**RE: Glendesto Subdivision
Grading & Drainage Report/Plan
Stamp 8-12-2016 (File: B18D020)**

**Re: Glendesto Subdivision – (DRB 1004472) B18-D020
Response to Email Comments dated July 19, 2016**

From: Carrillo, Abiel X. <acarrillo@cabq.gov>
Sent: Tuesday, July 19, 2016 11:32 AM
To: Diane Hoelzer
Subject: Glendesto Subdivision - B18D020 - Stamp Date 6-17-2016

GLENESTO SUBDIVISION
GRADING & DRAINAGE PLAN

SEE SHEET 2 FOR OFF-SITE
GRADING & DRAINAGE

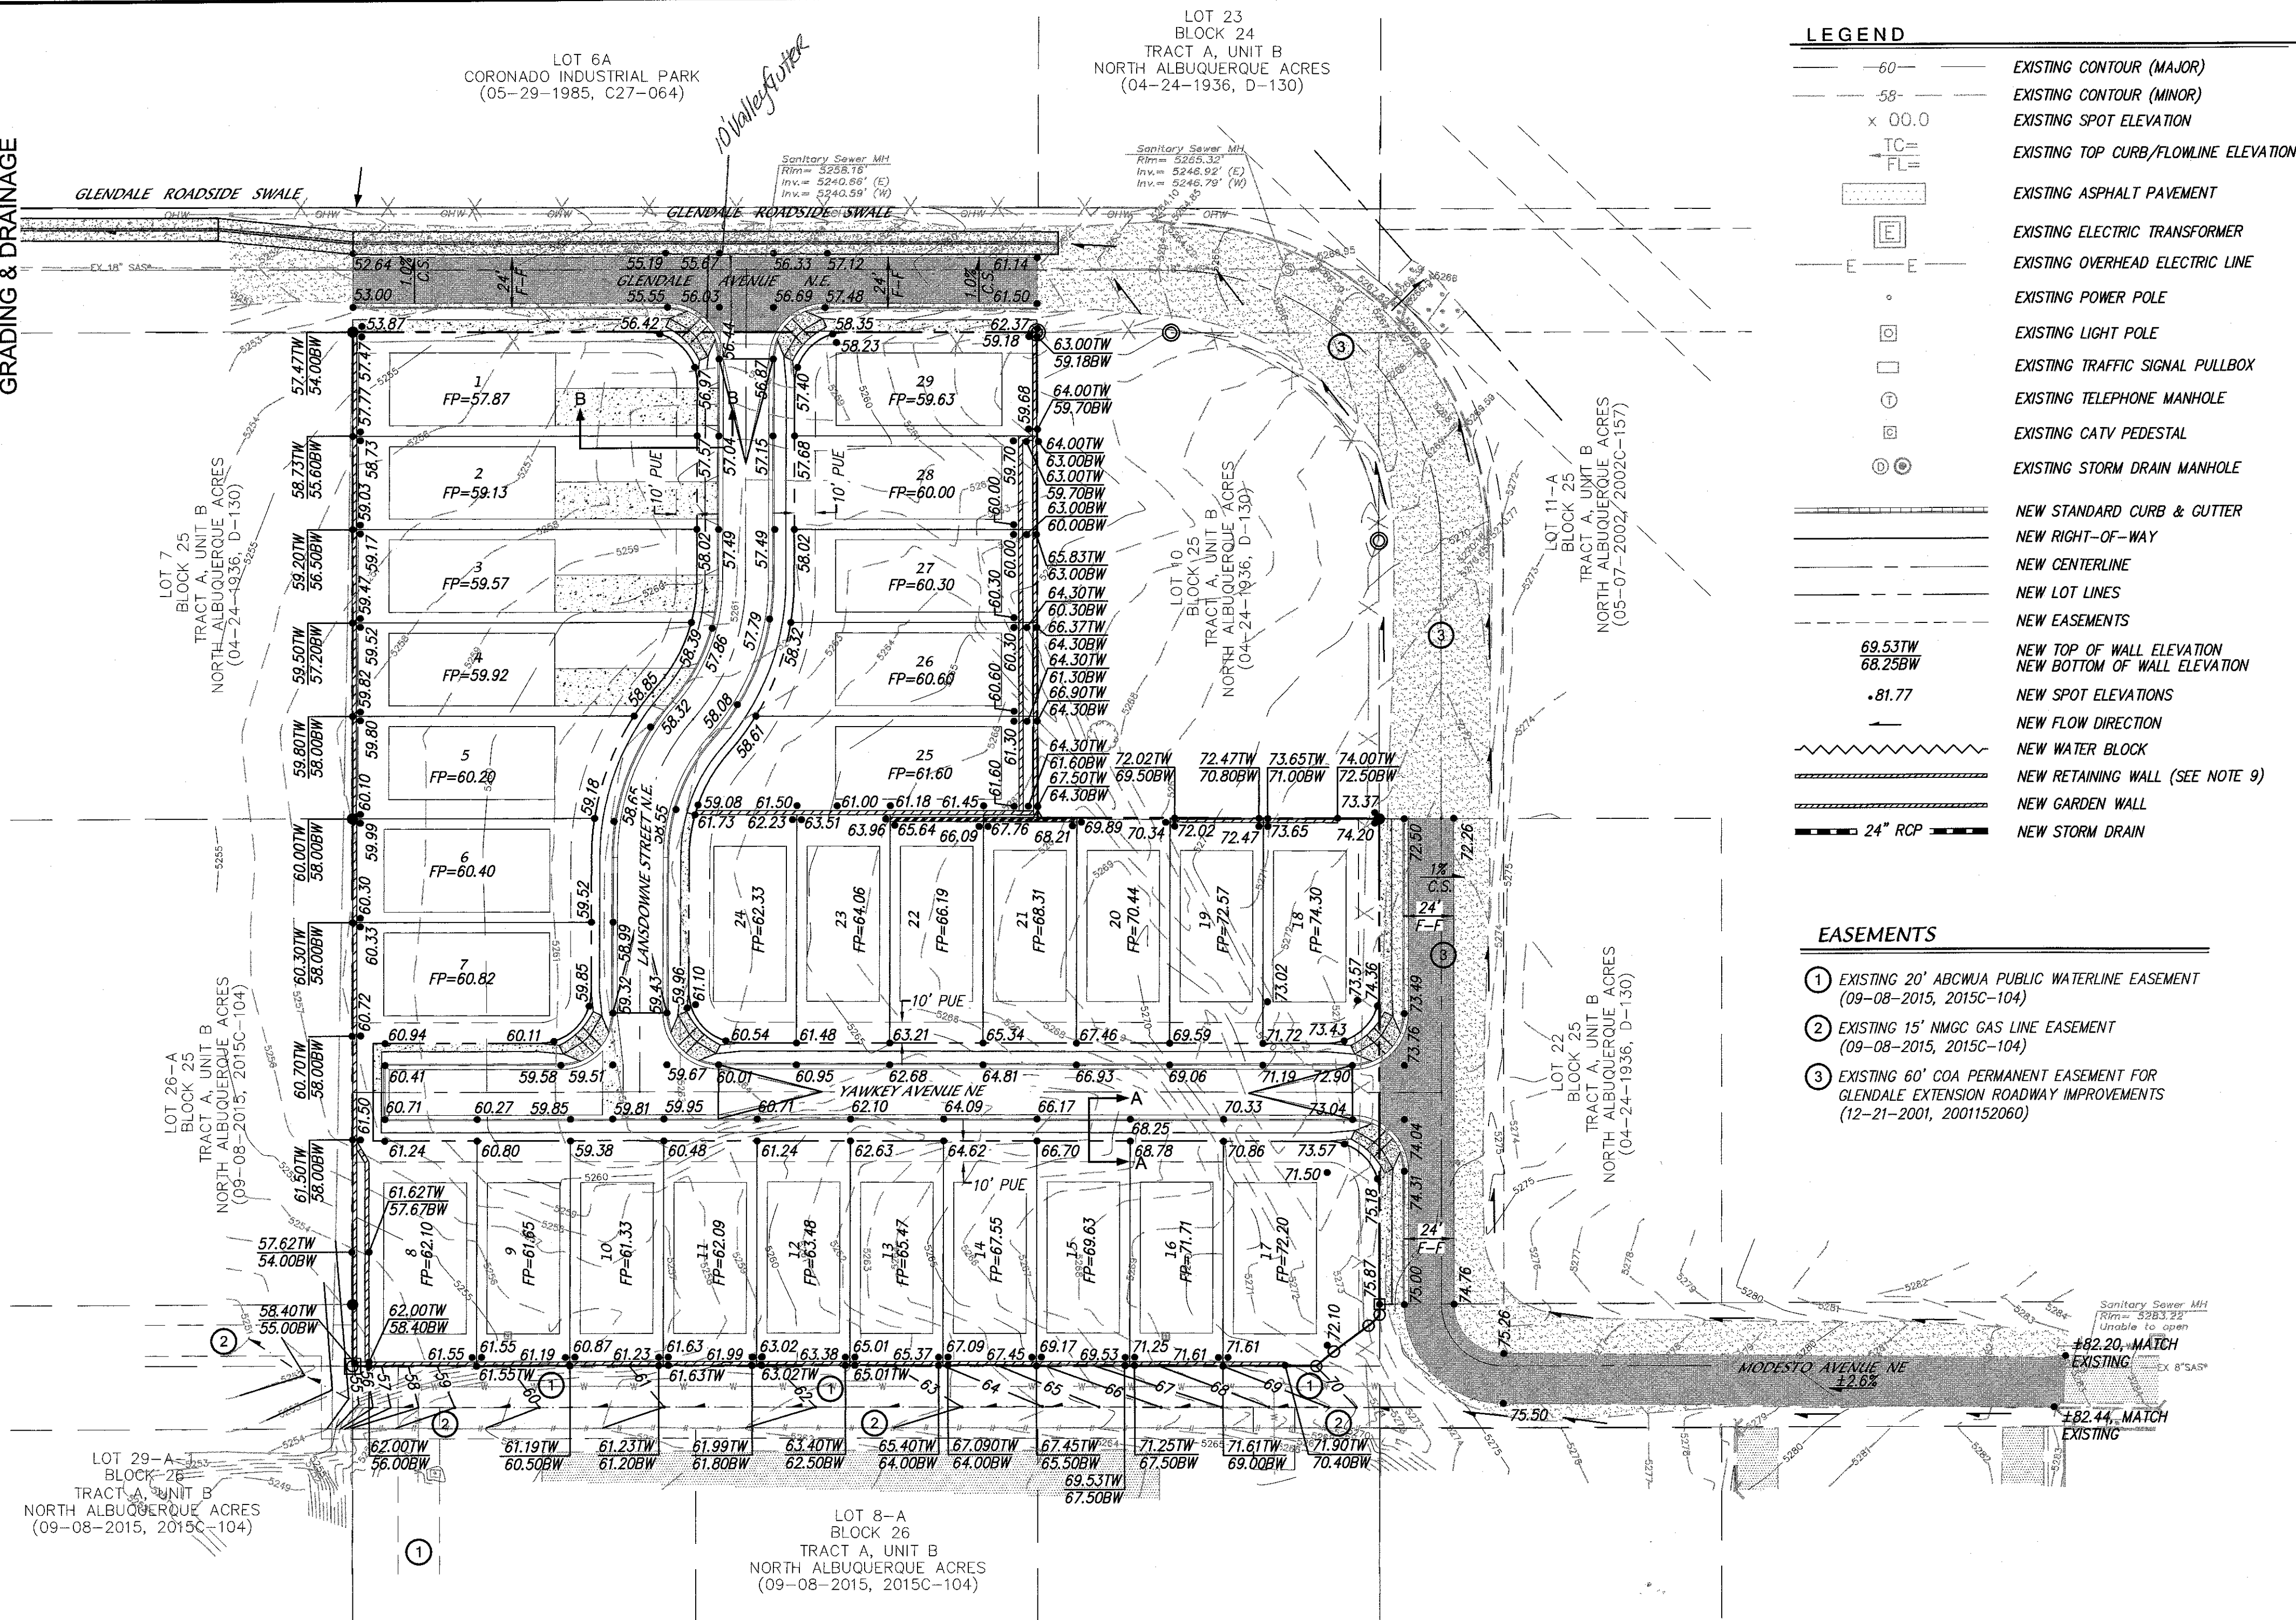
1. A valley gutter will be needed across Glendale Avenue for the outlet of surface flows from Lansdowne Ave. as a condition of Work Order approval.

2. The temporary road and the full roadway sections are proposed with a 1% cross-slope to the north and east, to convey flows to the north side of Glendale. The existing base course roadway is superelevated around the corners to offset the lack of a proper horizontal curve. The design of the road should maintain that superelevation towards the inside of the curve around the bends (and then it can be transitioned to direct drainage from the subdivision to the northside of Glendale Ave.)

3. Clarify the cross-slope/crown section of the Modesto section.
4. Show how the east end of the Glendale pavement transitions to the existing crown section.

5. Provide cut-off walls at the west end of the Glendale Section.
6. Clarify how flows are conveyed from Modesto into the vacated Modesto corridor, or if they are intended to turn north in a swale.

2. The proposed road section in Glendale and Modesto adjacent to the project site has been changed and is now 24' wide with curb and gutter on the south and west side only. The pavement section adjacent to Lot 10, Block 25 has been eliminated. As discussed and proposed to the DRB Transportation Engineer, "Eliminate the proposed pavement section adjacent to Lot 10, Block 25 between Glendale and Modesto Avenue. The residence from our proposed subdivision will not likely use this section of roadway. Residence leaving the subdivision to the east, will likely continue on Modesto Avenue to Louisiana Blvd. and residence exiting to the north to Glendale will continue west along Glendale to San Pedro south. Unless there is some other compelling reason to pave this section of roadway that is not part of covering our frontage, I would request this requirement be retracted."

3. Modesto Avenue will be a crowned section only.
4. This will be worked out at DRC.
5. A cut off wall will be added to the construction plans during DRC.

6. The current flows along the south side of Modesto Avenue will continue in the same historic flow pattern through the open corridor along the south property line of the proposed project site.

TITLE: **GLENDESTO SUBDIVISION
GRADING & DRAINAGE PLAN**

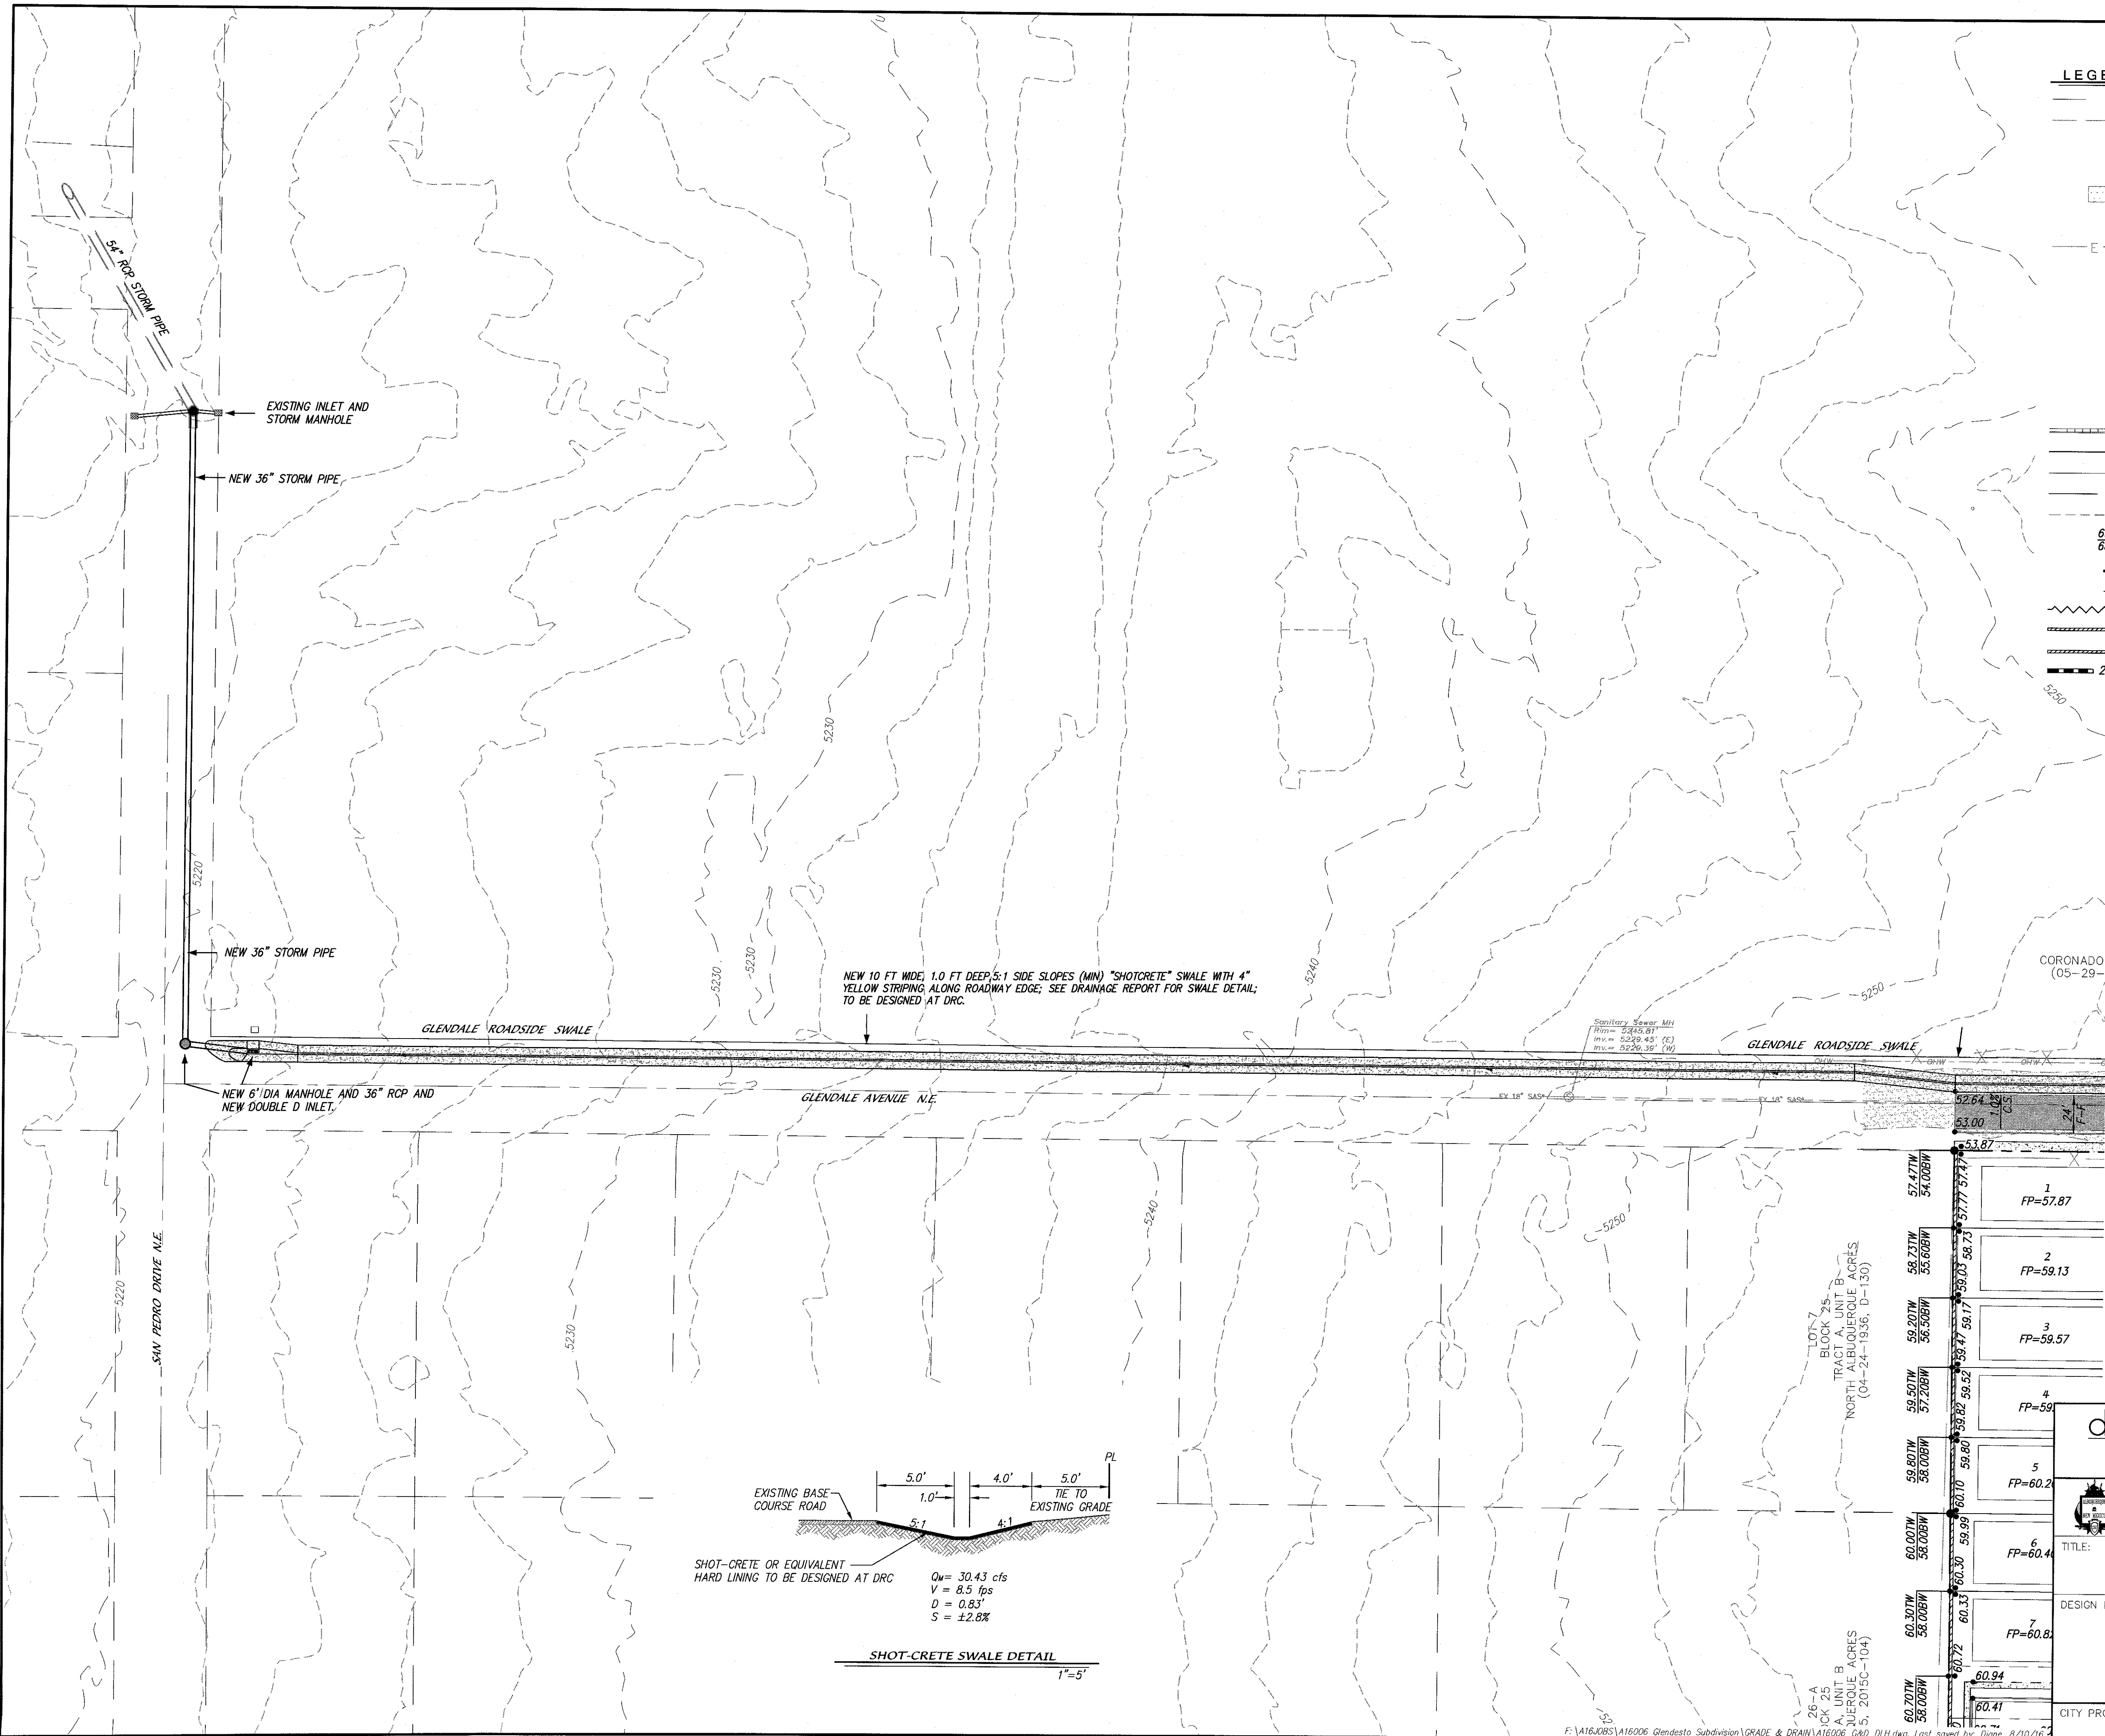
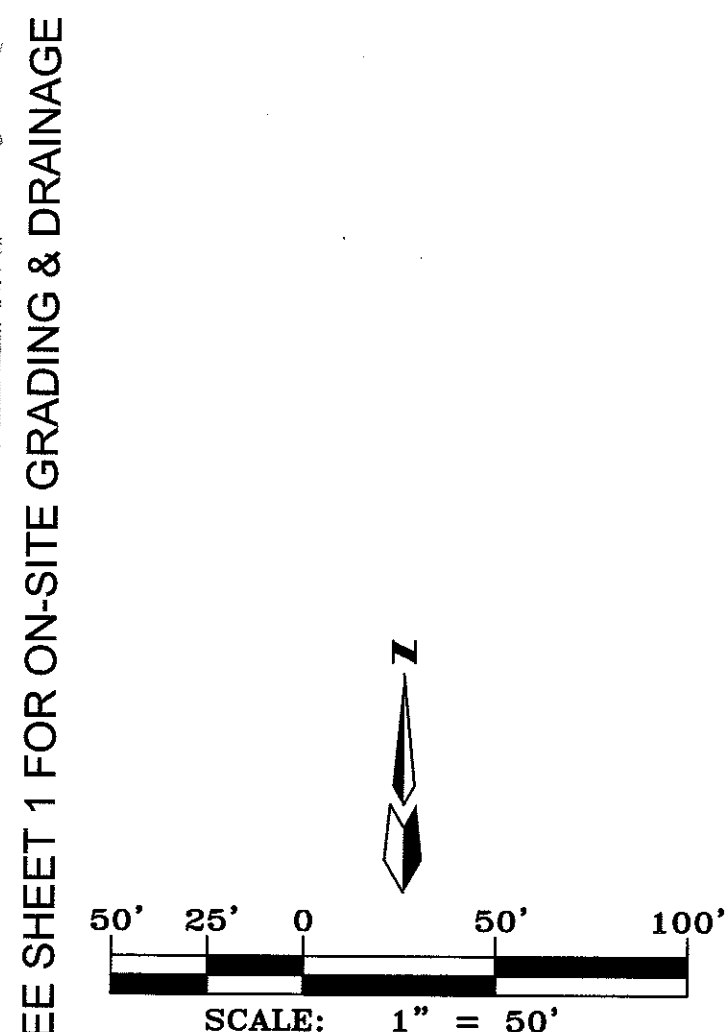
1. Conveying runoff flows along Glendale Ave appears to be acceptable as previously discussed. However there are issues with the conveyance into San Pedro:

- a. It does not seem feasible to continue the swale into San Pedro with a 90-degree turn; flow would be expected to travel at a high velocity at the end of Glendale.

- b. A swale does not seem to fit within the San Pedro Right of Way, without grading into the Sandia Pueblo property and relocating PNM poles. The extruded curb will not be an acceptable barrier, and it would be difficult to maintain.

1. The drainage plan has been revised to include a roadside swale along the north side of Glendale Avenue and connecting to a new 36" storm drain in San Pedro through a double D inlet in the bottom of the channel.

7. At this time, we are proposing to construct the 36" RCP storm drain in San Pedro and connect to the Glendale roadside swale.
